# CPED STAFF REPORT

CPC Agenda Item #6  
 May 5, 2014  
 BZZ-6500

*Property Location:* 1618-20 West Lake Street and 2915 James Avenue South  
*Project Name:* 16Twenty  
*Prepared By:* [Hilary Dvorak](#), Principal Planner, (612) 673-2639  
*Applicant:* Daniel Oberpriller with CPM Development LLC  
*Project Contact:* Brent Nelson with Peterssen/Keller architecture  
*Request:* To construct a new 3-story, 28,284 square foot, mixed-use building.  
*Required Applications:*

**1** ENCROACHMENT PLAN  
 A002 SCALE: 1/8" = 1'-0"

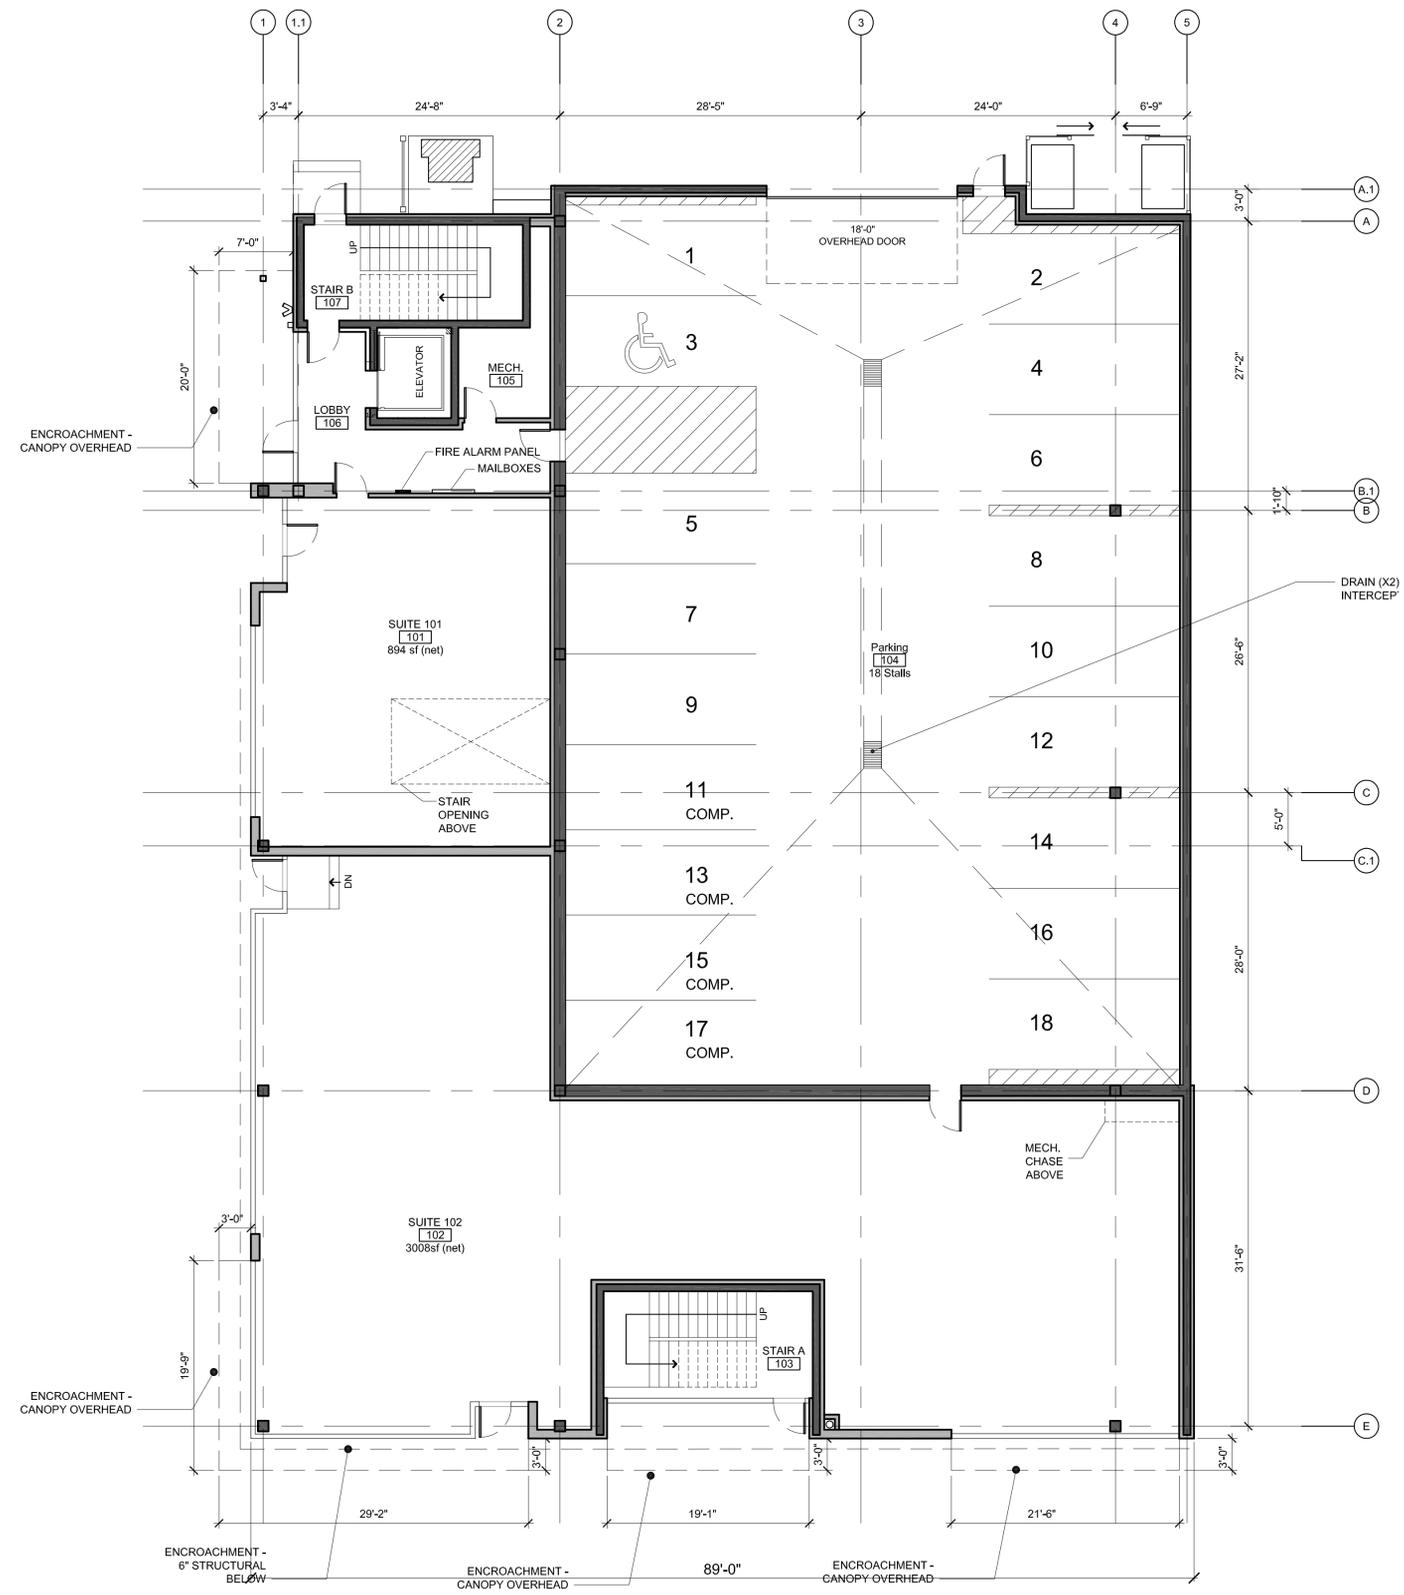
- In order to maximize the width of the public sidewalks it is recommended that the Applicant consider a 4'x6' tree grate rather than the 5'x5' grate identified in the plans.

- Proposed street trees appear to conflict with proposed building canopies; tree locations shall be modified to avoid any conflict with proposed canopy locations.

- Note #9 on Sheet C1 of the site plans shall be revised to read "Contact Tim Drew at 612-673-2152".
- Curb cuts for loading in the Public right-of-way are not allowed. Remove the loading zones from the plans as both are within the Public right-of-way and are reviewed through other means. Please contact Lonn Koranda at (612) 673-5726 if a loading zone is desired.

**1** FIRST FLOOR PLAN  
 A101 SCALE: 1/8" = 1'-0"

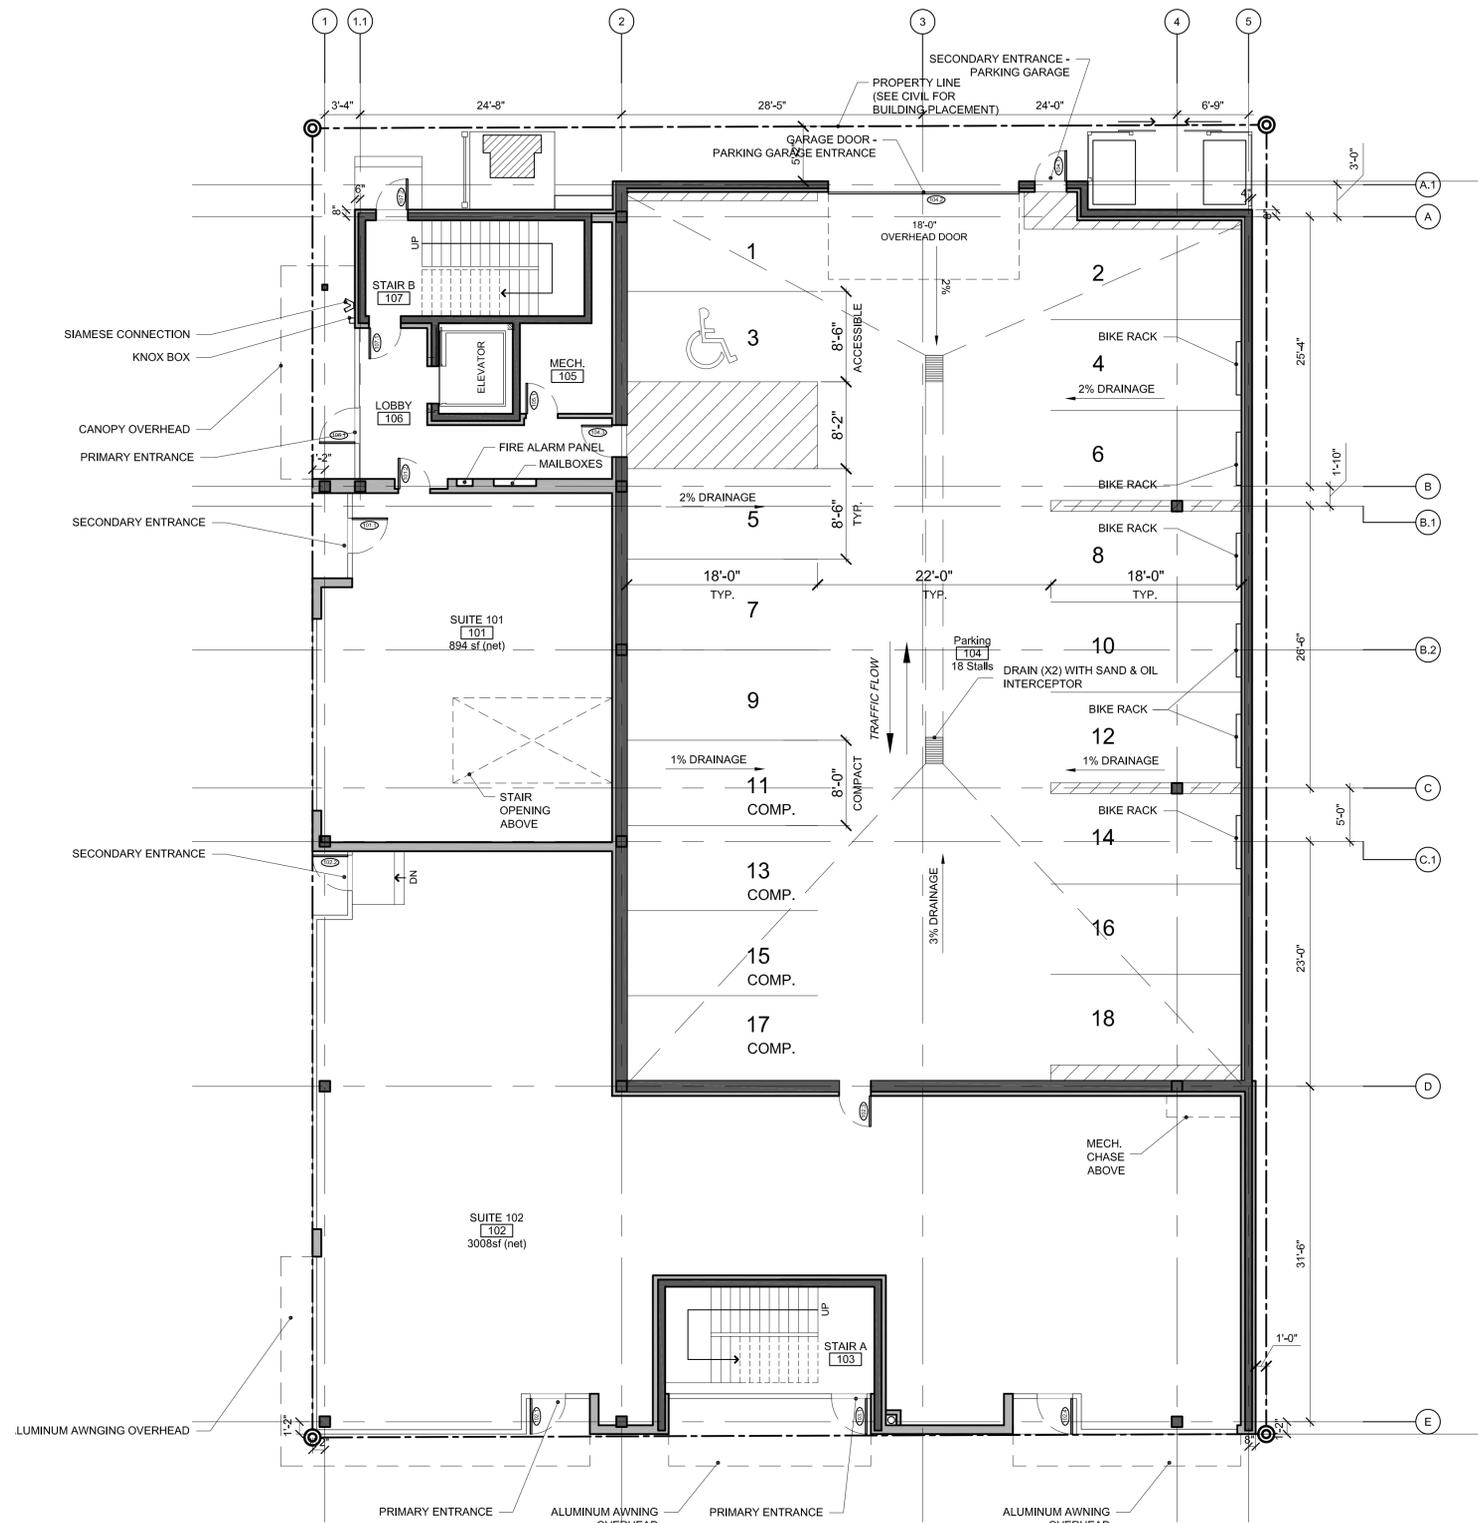
- The retail space titled Peterssen/Keller Architects will be addressed as 2919 James Avenue South.
  - The Lease 1B space identified on the first floor plans needs some clarification before it can be addressed. There are two doors identified. Which door will be the main entrance to the space?
